2018 - 2019 Cadillac ATS-V - CTS-V: Service Bulletin: #20-NA-054: Rear View Camera Guidance Lines Dim After Radio Replacement or Programming

#20-NA-054: Rear View Camera Guidance Lines Dim After Radio Replacement or Programming - (Mar 3, 2020)

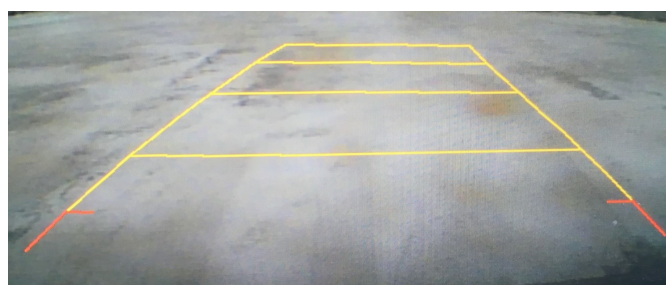
Some customers, after having radio replacement or radio reprogramming, may report that the Rear-View Camera (RVC) guidance lines are not as bold as previously viewed, that they are faint, see-through, thinner, dim, or translucent; and they used to be more visible. A comparison between similar vehicle models may, or may not, show a difference in rear view camera guidance line appearance.

Original design:

New design:

This may be caused by installing calibration files released in mid-2018 during radio replacement or reprogramming of the radio. The change to increase translucency was done to prevent the lines from obstructing objects in the field-of-view.

Do not attempt repairs. The thinner, lighter appearance of RVC guidance lines is operating to design intent.
